ANSTY GARDEN COMMUNITY,

DESIGNERS RESPONSE

REPORT REF NO. 2207280-R30

- **ACE Drawing 2207280-016C** – Proposed Mitigation Works
Tylers Green Roundabout

Drawing Title: **PROPOSED MITIGATION WORKS TYLERS GREEN ROUNDABOUT**

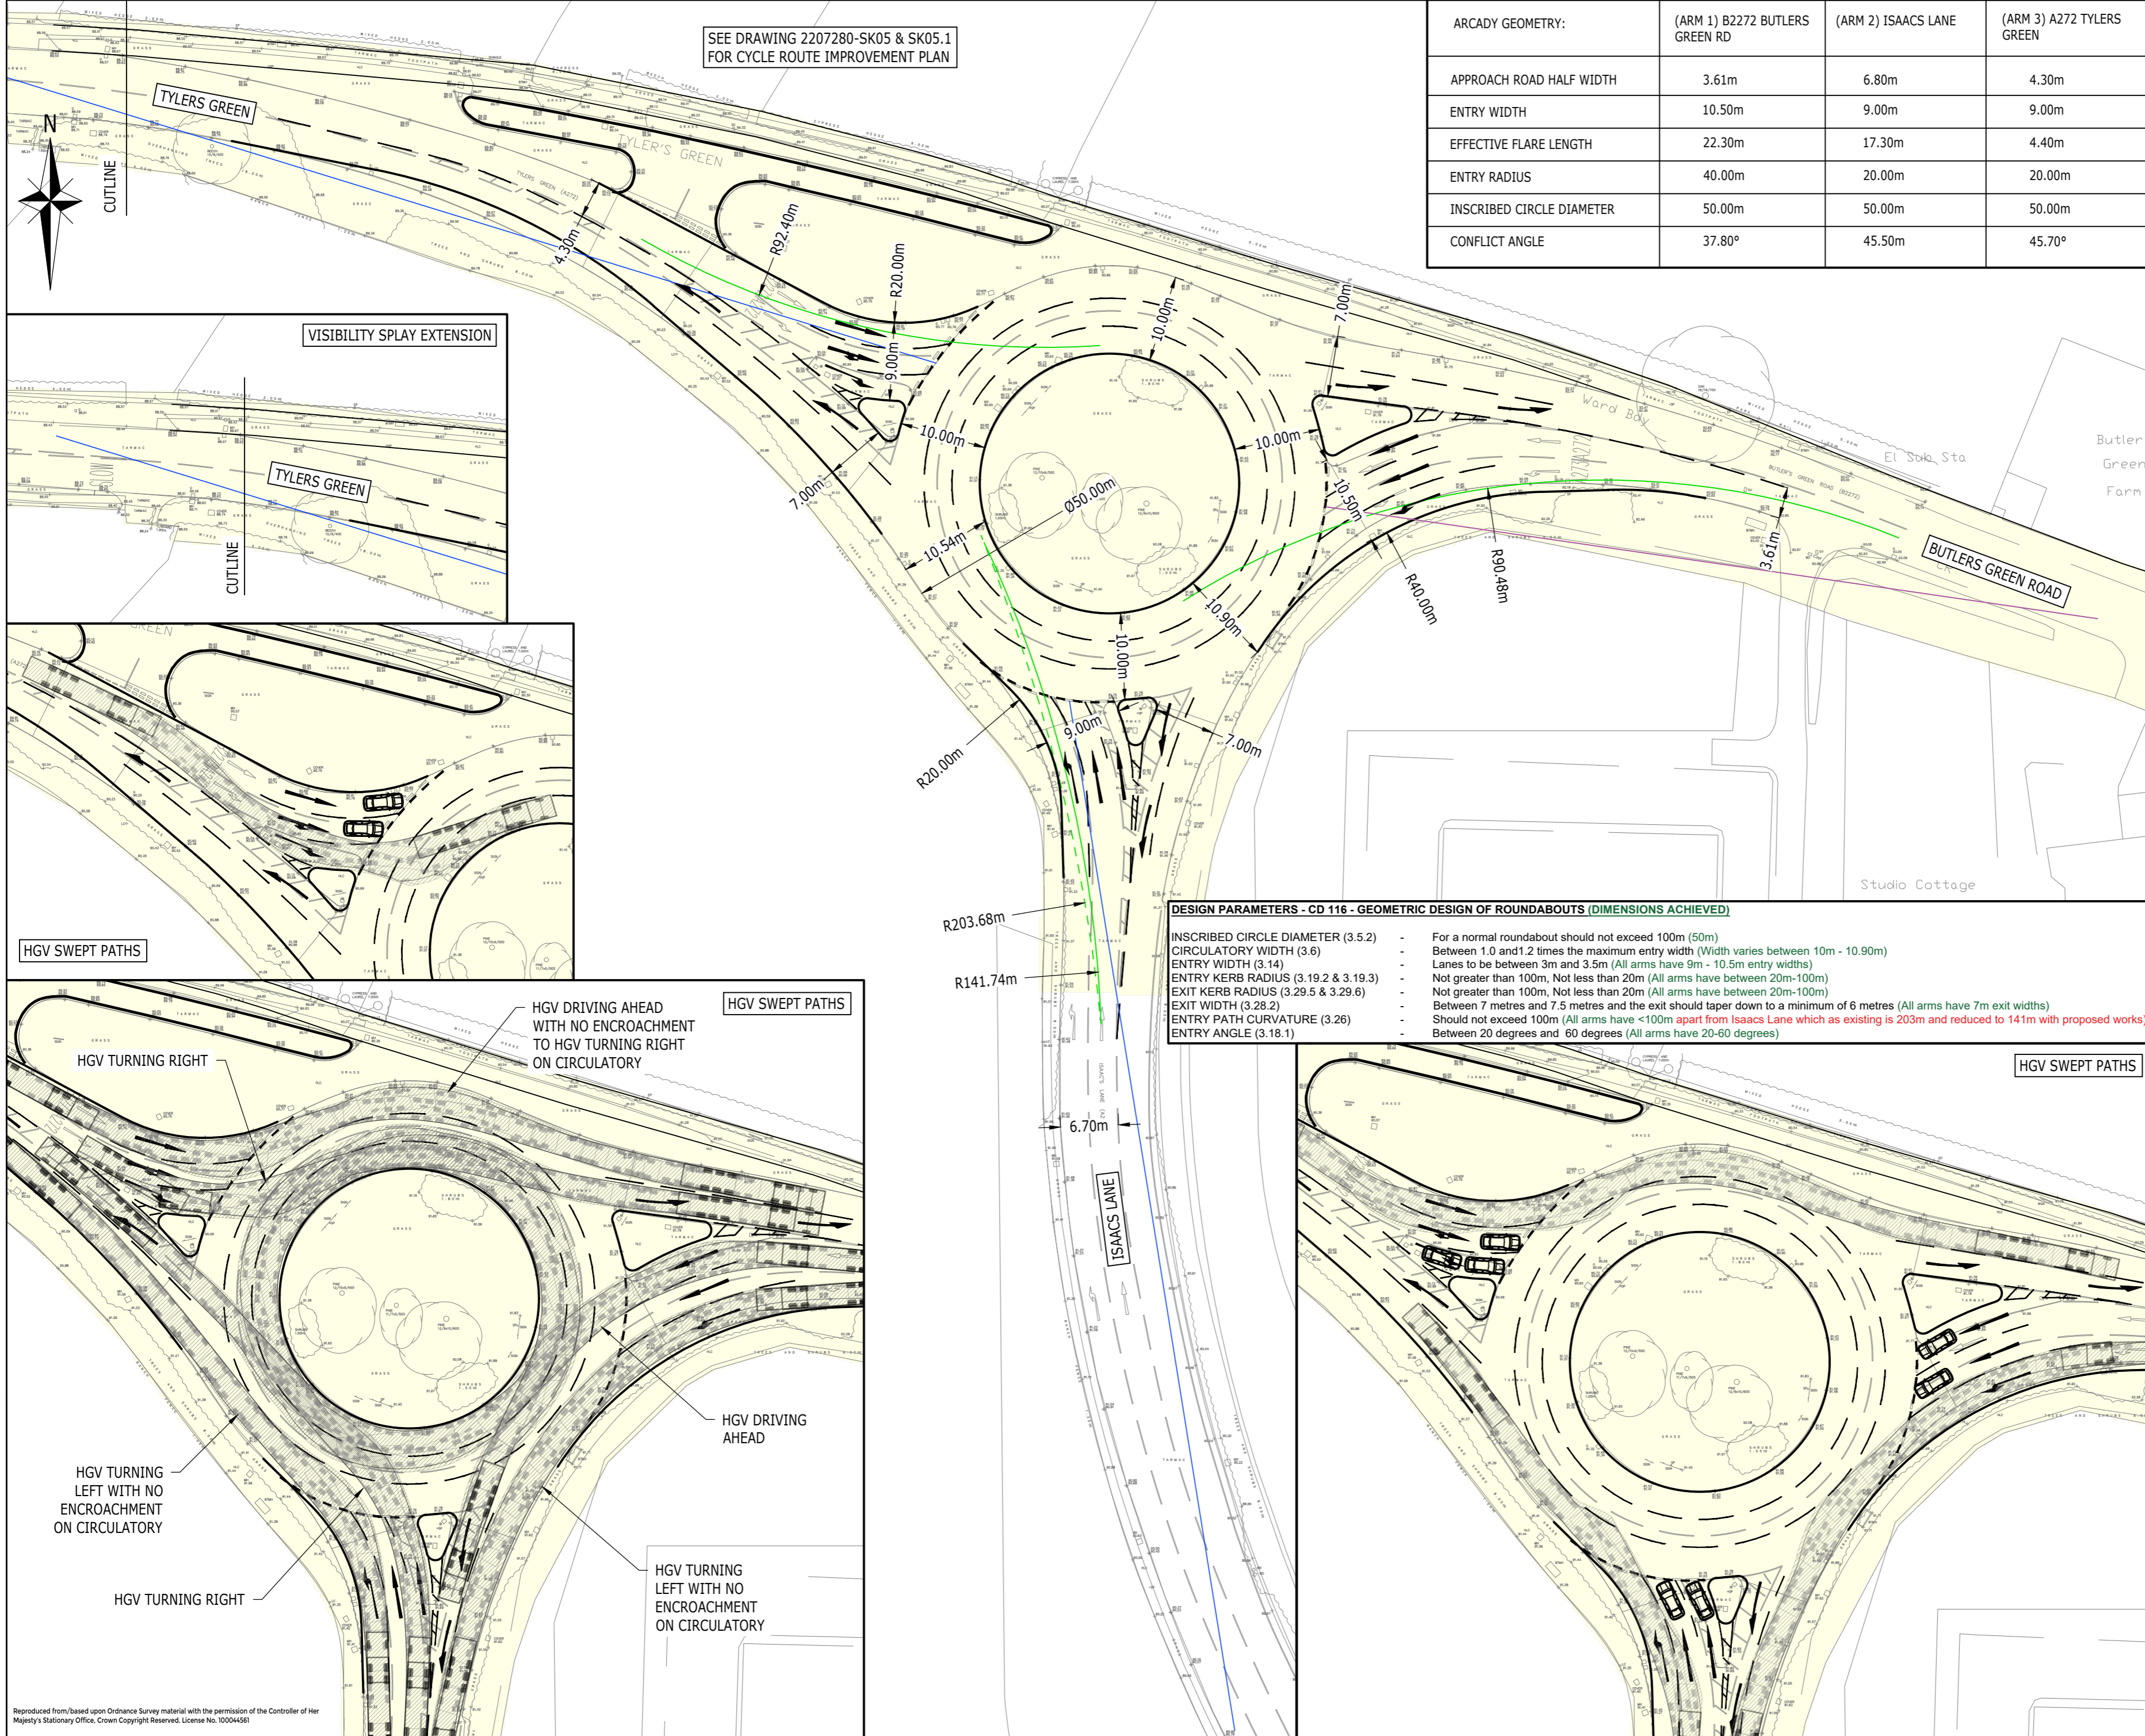
RSA problem	RSA recommendation	Design Organisation response	Overseeing Organisation response	Agreed RSA action
<p>3.1.1 Inappropriate surfacing could lead to overshoot collisions or rear end shunts.</p> <p>Kerblines are proposed to be altered, where the proposals do not include the introduction of anti-skid surfacing or detail the Polished Stone Value (PSV) to be used on the approaches to the roundabout. Surfacing with an insufficient PSV could lead to overshoot or rear end shunt collisions. Further, vehicles approaching the roundabout may be straddling two different surface types and may experience differential braking, which under sudden severe braking conditions could lead to loss of control collisions.</p>	<p>It is recommended high friction surfacing or surfacing with a high PSV be provided on all the approaches to the roundabout.</p>	<p>Details of PSV values and surfacing materials will be provided for Stage 2 Audit.</p>	<p>High friction surfacing should be provided and details of PSV values to be provided at detailed design stage.</p>	<p>High friction surfacing to be provided and details of PSV values to be provided at detailed design stage.</p>

<p>3.1.2 Surface water on carriageway could lead to loss of control collisions.</p> <p>Kerblines are proposed to be altered, where at this early stage no details of the drainage proposals or carriageway profiles have been provided for assessment. Low or flat areas may cause ponding of surface water. This could be detrimental to road safety and could lead to loss of control collisions.</p>	<p>It is recommended drainage details, cross sections and vertical profiles should be provided at Safety Audit Stage 2.</p>	<p>Agree. Drainage details, cross sections and vertical profiles will be provided for Stage 2 Audit.</p>	<p>Drainage details to be provided at detailed design.</p>	<p>Drainage details to be provided at detailed design.</p>
<p>3.2.1 Lack of forward visibility may increase the risk of junction related or shunt type collisions at the roundabout.</p> <p>Stopping Sight Distances have been provided for assessment, where there is concern that the forward visibility splay on the east and westbound approaches pass over non-highway land. Vegetation or trees in these splays could restrict visibility, where insufficient visibility may increase the risk of junction related or shunt type collisions at the roundabout.</p>	<p>It is recommended that the forward visibility splays be within the adoptable highway, or that a suitable covenant be arranged to ensure that the splay is not obstructed by vegetation.</p>	<p>Agree. Visibility splays are within highway land, as denoted by the yellow shading. Vegetation will be maintained within the visibility splay to ensure vegetation does not obstruct splay.</p>	<p>Visibility splays to be provided within Highway Land and maintained to ensure vegetation does not obstruct the visibility splays.</p>	<p>Visibility splays to be suitably maintained and kept clear.</p>

<p>3.2.2 Length of right turn lane could increase the risk of rear end shunts or side swipe collisions.</p> <p>On the eastbound approach to the roundabout there is a short right turn lane, where predicted movements are unknown. Should the number of vehicles exceed the length of the proposed right turn lane, this could lead to queuing vehicles straddling the offside straight-ahead lane. This could increase the risk of rear end shunts, or sudden lane changes into the nearside straight-ahead lane and side swipe collisions.</p>	<p>It is recommended that length of the right turn lane be comparable with predicted turning movements.</p>	<p>Disagree. As shown on ACE Drawing 2207280-016C, both lane 2 and lane 3 can be utilised by vehicles turning right.</p> <p>In the future year scenario 474 vehicles would turn right and 1,042 vehicles would go straight ahead in the AM peak hour, whilst 356 vehicles would turn right and 731 vehicles would go straight ahead in the PM peak hour.</p> <p>As such, use of the right turn lane is comparable to the lower use of the right turn, whilst the arrangements shown will help comparative use of lanes to be appropriately more equal to reflect demand and ensure efficient operation of the roundabout and approach lanes.</p>	<p>Right turning vehicles will be able to utilise both the middle and right hand lanes. When the length of the both opportunities are compared to those afforded to straight ahead vehicles (left and middle lanes) the provision would appear appropriate.</p>	<p>No further action at this stage.</p>

<p>3.3.1 Insufficient capacity may lead to rear end shunts or side impact collisions.</p> <p>Modelling results were provided for assessment, where Arms 1 has an RFC value of 0.85 or more in 2039. Excessive queuing at</p>	<p>It is recommended that the roundabout should operate without excessive queuing or that an alternative junction arrangement be considered.</p>	<p>Disagree. The roundabout offers improved capacity compared to the existing arrangement.</p> <p>Traffic is dynamic, people will alter their travel behaviours to avoid delay, either by rerouting, or staggering travel times.</p>	<p>The modelling results would indicate junction offers a suitable level of mitigation when compared to the do nothing scenario.</p>	<p>No further action at this stage.</p>

<p>the roundabout could lead to driver frustration and the use of inappropriate gaps, which may lead to rear end shunts or side impact collisions. However, it is recognised that the proposed mitigation works improve the capacity of the roundabout from existing.</p>				
<p>3.3.2 Insufficient carriageway space could lead to side swipe collisions or head on collisions.</p> <p>A three-lane circulatory carriageway is proposed at the roundabout; however, no swept path information has been provided for assessment. Insufficient carriageway space may lead to vehicles entering adjacent running lanes which could increase the risk of side swipe collisions.</p>	<p>It is recommended that swept paths be provided for assessment.</p>	<p>Agree. ACE Drawing 2207280-D016C shows the vehicle tracking for the roundabout.</p> <p>A 16.5m Artic can manoeuvre through the junction without encroachment on the adjacent lane(s) when on the roundabout for all left (1st exit) turns through the junction. For right turns (2nd exit) there is similar encroachment as is currently seen at the junction and so no significant change in overrun for what does make up only a small (4% AM peak hour and 1% PM peak hour) of turning movements through the junction.</p> <p>It should be further noted that where encroachment into the adjacent lane is required for HGVs, that this takes place where there are x2 lane of traffic using a total</p>	<p>Swept path tracking has been provided for all moves at the junction. The tracking show that a max length HGV would encroach in adjoining lanes.</p> <p>The encroachment would be similar to the existing junction layout.</p>	<p>No further action at this stage.</p>

<p>of x3 lanes of road space, meaning there is appropriate space for overrun to take place when on the junction. Where there are only x2 lanes being used by x2 streams of traffic, there is no encroachment required at all.</p> <p>Circulatory lane widths are drawn to the standard 1-1.2 x the entry width in accordance with DMRB guidance.</p>		
<p>3.3.3 High entry path radius may increase the risk of loss of control or junction related collisions on the roundabout.</p> <p>The northbound approach (Issacs Lane) to the roundabout has a proposed entry path radius (EPR) of 141.74m, though it is recognised that this is an improvement on the existing EPR of 203.68m. This may lead to high entry speeds from this direction, consequently increasing the risk of loss of control type collisions from the south, or junction fail to give way type collisions with vehicles that have entered from the Issacs Lane.</p>	<p>It is recommended that entry path radius is checked with current design standards and adjusted if necessary.</p>	<p>Disagree. Land ownership constraints are such that the ability to alter the approach geometry of the southern arm to reduce the entry path radius to below 100m is hindered.</p> <p>The proposed arrangements are an improvement on the existing arrangements where the current entry path radius is 203m but the proposed design accommodates a 141m entry path radius.</p> <p>As such, this is an acceptable junction design since it offers an improvement over the current design.</p>	<p>The entry path radius is an improvement on the existing junction layout. A Departure from Standard form should be submitted for consideration.</p>	<p>Departure from Standard form has been completed and issued to WSCC.</p>

<p>3.3.4 Junction arrangement could increase the risk of rear end shunts or side impact collisions.</p> <p>On the westbound exit from the roundabout there is a merge from two lanes to one that is located at the Tylers Green junction with Tylers Green spur road. Vehicle movements at the junction are likely to be low and there is concern that westbound traffic will not be expecting a vehicle waiting to turn right, which could increase the risk of rear end shunts. Similarly, westbound traffic may not expect traffic to emerge from this junction and undertake a right turn manoeuvre, particularly as there is a nearby roundabout that should ease turning movements. This could increase the risk of side impact collisions.</p>	<p>It is recommended that the junction be a left in / left out arrangement.</p>	<p>Disagree. Vehicles exiting the roundabout will be travelling at low speeds, leading to an increased reaction distance and so potential for rear end shunts is negligible.</p> <p>Any right turning queuing vehicle will be queuing against vehicles queuing at the roundabout entrance where there is just one lane of traffic. It is prevalent for queuing vehicles to allow vehicles to cross into a side junction when their own path is queuing.</p> <p>Furthermore, the additional time taken to u-turn should a left in/left out be proposed would likely lead to some drivers turning right in/out which in itself would be a safety concern and there would be limited opportunity to enforce the left in/out arrangements.</p>	<p>The number of movements would be very low and no recorded accidents are detailed with the existing all moves arrangement from the side road.</p> <p>Vehicles are unlikely to travel to the nearest roundabout to the west to U turn and could undertake inappropriate movements in driveways of number of properties with direct access to the A272 between the roundabouts.</p>	<p>No amendments to the design necessary. No further action at this stage.</p>

C	UPDATED FOLLOWING WSCC COMMENTS 25.04.25	DV	DV	DH	12-05-25
B	WHITE LINING AMENDED	SC	JS	DH	11-02-25
A	ADDITION OF VEHICLE TRACKING	DV	JS	DH	09-01-25
Rev	Description	Drn	Chk	App	Date

Plan attached showing the locations of the problems identified as part of this audit (location numbers refer to paragraph numbers in the report).

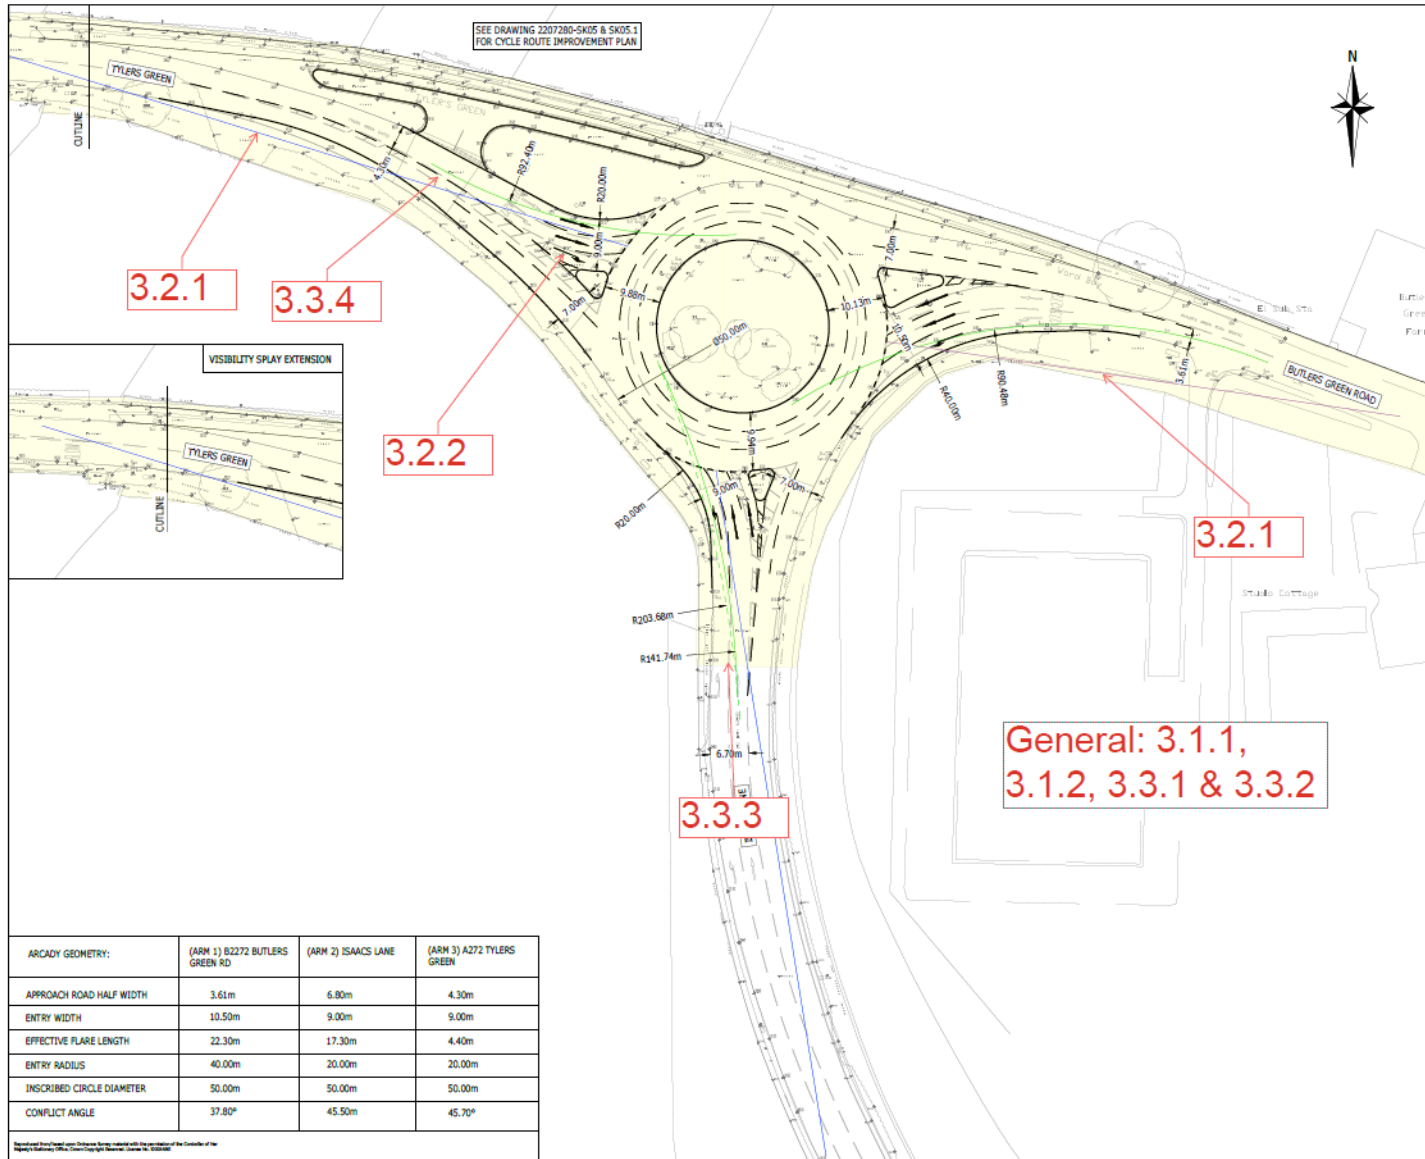
Location: Approaches to the roundabout.

Summary: Inappropriate surfacing could lead to overshoot collisions or rear end shunts.

Kerblines are proposed to be altered, where the proposals do not include the introduction of anti-skid surfacing or detail the Polished Stone Value (PSV) to be used on the approaches to the roundabout. Surfacing with an insufficient PSV could lead to overshoot or rear end shunt collisions. Further, vehicles approaching the roundabout may be straddling two different surface types and may experience differential braking, which under sudden severe braking conditions could lead to loss of control collisions.

It is recommended high friction surfacing or surfacing with a high PSV be provided on all the approaches to the roundabout.

Location: Approaches to the roundabout.

Summary: Surface water on carriageway could lead to loss of control collisions.

Kerblines are proposed to be altered, where at this early stage no details of the drainage proposals or carriageway profiles have been provided for assessment. Low or flat areas may cause ponding of surface water. This could be detrimental to road safety and could lead to loss of control collisions.

It is recommended drainage details, cross sections and vertical profiles should be provided at Safety Audit Stage 2.

Location: East and westbound approaches to roundabout.

Summary: Lack of forward visibility may increase the risk of junction related or shunt type collisions at the roundabout.

Stopping Sight Distances have been provided for assessment, where there is concern that the forward visibility splay on the east and westbound approaches pass over non-highway land. Vegetation or trees in these splays could restrict visibility, where insufficient visibility may increase the risk of junction related or shunt type collisions at the roundabout.

It is recommended that the forward visibility splays be within the adoptable highway, or that a suitable covenant be arranged to ensure that the splay is not obstructed by vegetation.

Location: Eastbound approach to roundabout.

Summary: Length of right turn lane could increase the risk of rear end shunts or side swipe collisions.

On the eastbound approach to the roundabout there is a short right turn lane, where predicted movements are unknown. Should the number of vehicles exceed the length of the proposed right turn lane, this could lead to queuing vehicles straddling the offside straight-ahead lane. This could increase the risk of rear end shunts, or sudden lane changes into the nearside straight-ahead lane and side swipe collisions.

It is recommended that length of the right turn lane be comparable with predicted turning movements.

Location: Proposed roundabout.

Summary: Insufficient capacity may lead to rear end shunts or side impact collisions.

Modelling results were provided for assessment, where Arms 1 has an RFC value of 0.85 or more in 2039. Excessive queuing at the roundabout could lead to driver frustration and the use of inappropriate gaps, which may lead to rear end shunts or side impact collisions. However, it is recognised that the proposed mitigation works improve the capacity of the roundabout from existing.

It is recommended that the roundabout should operate without excessive queuing or that an alternative junction arrangement be considered.

Location: Proposed roundabout.

Summary: Insufficient carriageway space could lead to side swipe collisions or head on collisions.

A three-lane circulatory carriageway is proposed at the roundabout; however, no swept path information has been provided for assessment. Insufficient carriageway space may lead to vehicles entering adjacent running lanes which could increase the risk of side swipe collisions.

It is recommended that swept paths be provided for assessment.

Location: Northbound approach to roundabout.

Summary: High entry path radius may increase the risk of loss of control or junction related collisions on the roundabout.

The northbound approach (Issacs Lane) to the roundabout has a proposed entry path radius (EPR) of 141.74m, though it is recognised that this is an improvement on the existing EPR of 203.68m. This may lead to high entry speeds from this direction, consequently increasing the risk of loss of control type collisions from the south, or junction fail to give way type collisions with vehicles that have entered from the Issacs Lane.

It is recommended that entry path radius is checked with current design standards and adjusted if necessary.

Location: Tylers Green junction with Tylers Green spur road.

Summary: Junction arrangement could increase the risk of rear end shunts or side impact collisions.

On the westbound exit from the roundabout there is a merge from two lanes to one that is located at the Tylers Green junction with Tylers Green spur road. Vehicle movements at the junction are likely to be low and there is concern that westbound traffic will not be expecting a vehicle waiting to turn right, which could increase the risk of rear end shunts. Similarly, westbound traffic may not expect traffic to emerge from this junction and undertake a right turn manoeuvre, particularly as there is a nearby roundabout that should ease turning movements. This could increase the risk of side impact collisions.

It is recommended that the junction be a left in / left out arrangement.
